# P802.3bt D3.0 – Fixes to the Autoclass state diagram v105

## Info (not part of baseline)

**Figure 145-14 — PSE Autoclass state diagram**

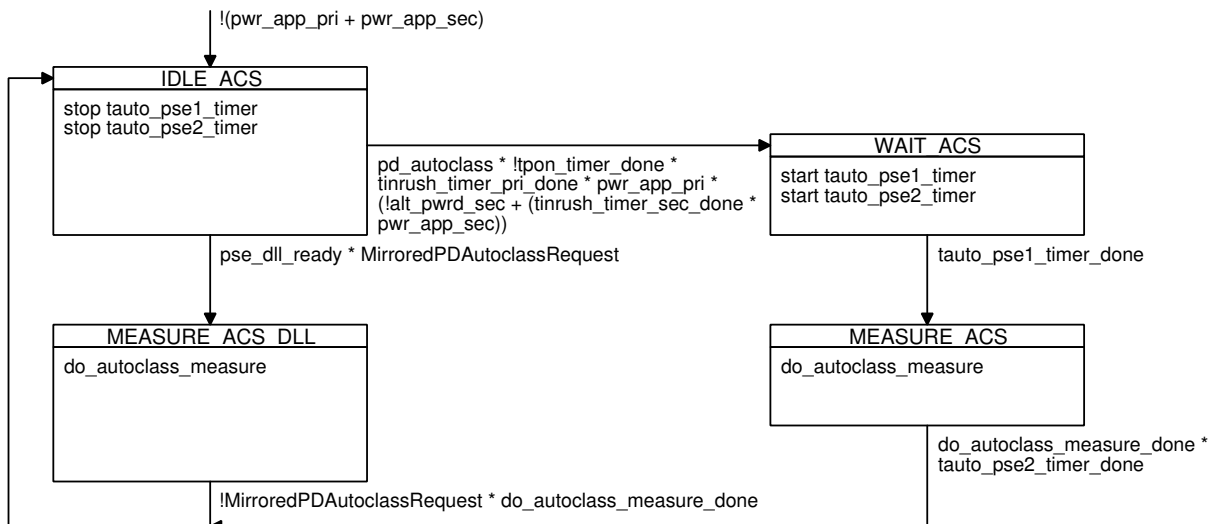
On the PSE side there is a loop / race condition coming out of `MEASURE_ACS`. The `MirroredPDAutoclassRequest` gets reset to `FALSE` by the PD, but that takes time. When the PSE has concluded a measurement, it will go back to `IDLE_ACS` and immediately flip back into `MEASURE_ACS`. The solution is to make the PSE wait in `MEASURE_ACS_DLL` until the PD has cleared the `MirroredPDAutoclassRequest`.

As part of a wider problem in the DLL state diagrams: it is necessary to set 'Mirrored\_\*' variables prior to proceeding to states where those variables are read. If there hasn't been an incoming LLDPDU yet, the Mirrored variables have an undefined value and this causes undefined state diagram behavior.

Replace Figure 145-14 as follows:

Figure 145–27 — Single-signature PD Autoclass state diagram

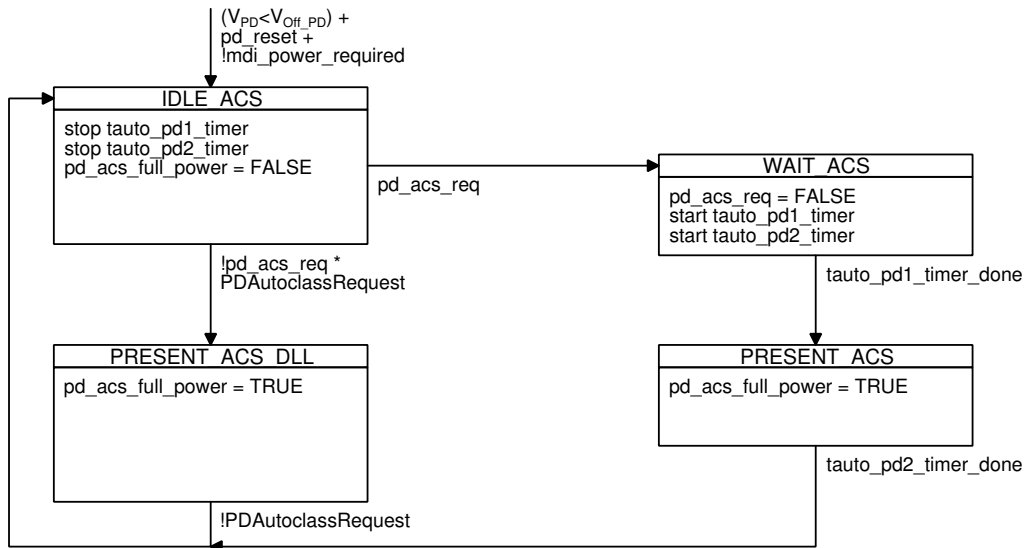
Because `pd_acs_req` is set to `FALSE` in the `IDLE_ACS` state (which is executed continuously until  $V_{PD} > V_{Off\_PD}$ ), the PD instantly forgets it has to do Autoclass based on Physical Layer. By clearing `pd_acs_req` in `WAIT_ACS`, we no longer can have a single `PRESENT_ACS` state because we can't distinguish the exit conditions.

We now also need to reset `pd_acs_req` in the main state diagram to prevent an issue with PD resets happening after `DO_CLASS_EVENT_AUTO` but prior to `INRUSH`.

Add the following statements to the **IDLE** state in Figure 145–26:

```
pd_acs_req ← FALSE
```

Replace Figure 145–27 as follows:
